**Re: Defect Information Report – Supplemental Report No. 1
10V-100, FL-574, C2 Air Door Switch**

Subject: RECALL 10V-100 – AG2 Entrance Door Position Switch Replacement

Recall 10V-100

SUBJECT: AG2 AIR ENTRANCE DOOR POSITION SWITCH REPLACEMENT
WITH 2-POSITION CONTROL SWITCH

Figure 1 - Built prior to 9/21/09

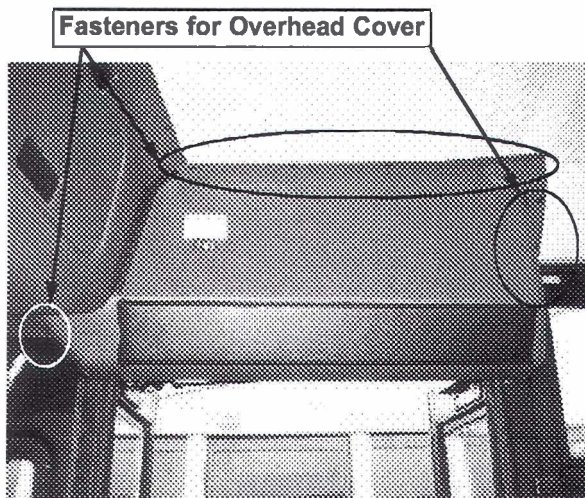
1. Chock the tires and be sure the ignition key is in the "Off" position.
2. On units built prior to 9/21/09, remove the entrance door overhead cover. This is done by removing the nine (9) fasteners located at the front, top and rear of the cover. **Figure 1.** On units built on or after 9/21/09, remove the three access panel screws and lower the panel. **Figure 2**

Figure 3

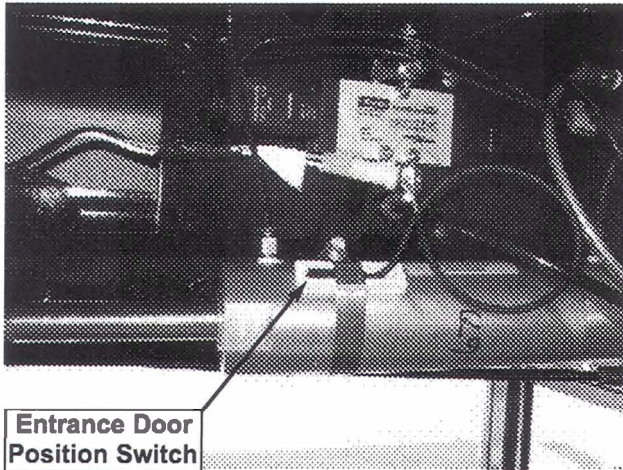
3. Locate the entrance door position switch clamped to the air actuator. **Figure 3**
4. Disconnect the entrance door position switch from the body harness by cutting the wires behind the connector. **Figure 4**

Figure 5

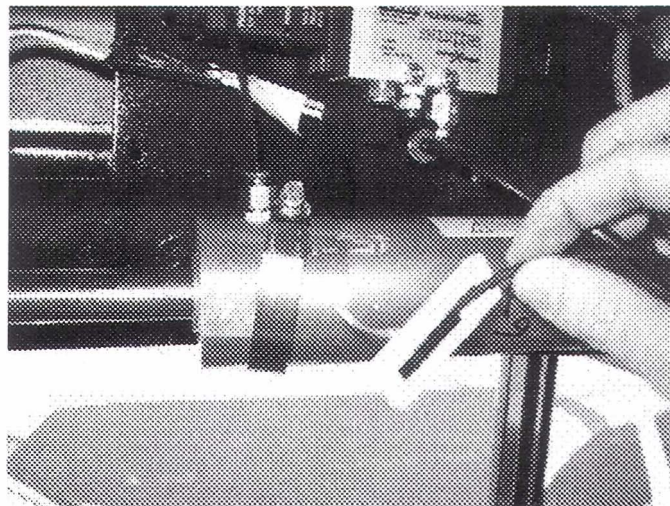
5. Remove and discard the band clamp, old entrance door position switch, and plastic housing. **Figure 5**

Figure 6

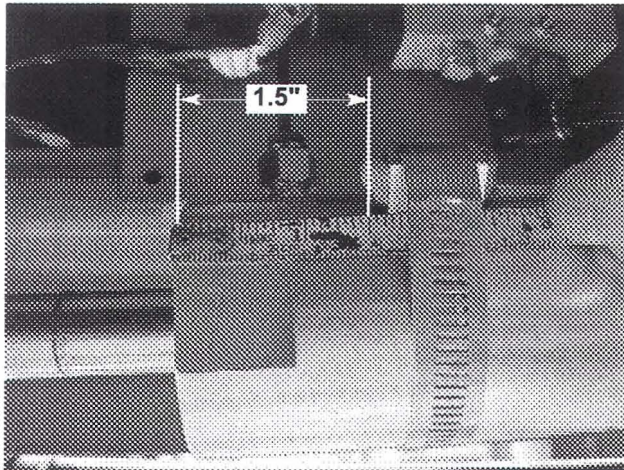
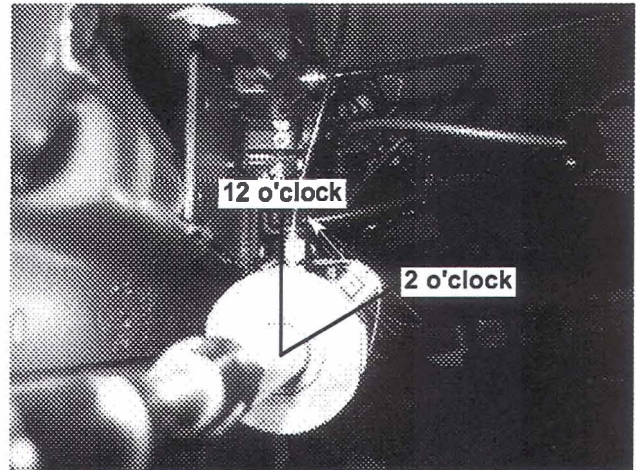
6. Install new entrance door position switch, #TBB 165692 with the new band clamp, #TBB164982 loosely on the actuator. Install the switch so that its end is one and one half inches (1.5") from the end of the actuator body. It should be positioned between 12 o'clock and 2 o'clock as referenced from the actuator fittings. The band clamp should be centered on the aluminum housing. Tighten the band clamp to 20 in-lbs. **Figures 6 & 7**

Figure 8

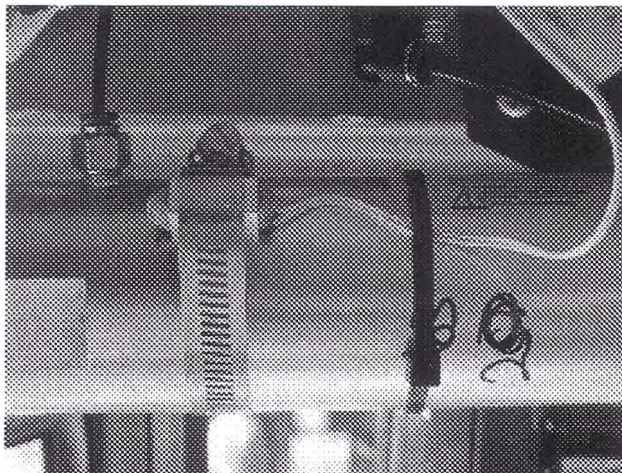
7. Place the tie wrap around the switch wires and actuator body. This will act as a strain relief for the entrance door position switch wiring. **Figure 8**
8. Splice the new switch to the body harness; black switch wire to white body wire, and tan to tan. Pull on the wires from each side of the splices to ensure a good connection was made. **Figure 9**

Figure 10

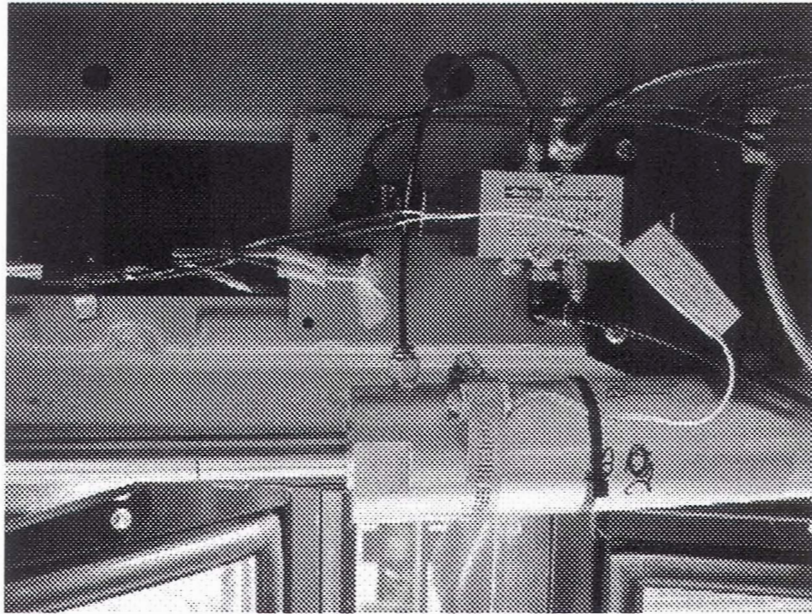
9. Bundle and tie wrap the excess wire at the body harness. Leave enough wire for air actuator to move freely during operation. DO NOT tie or pull on heat shrunk area of wire. A resistor is installed in this location. **Figure 10**
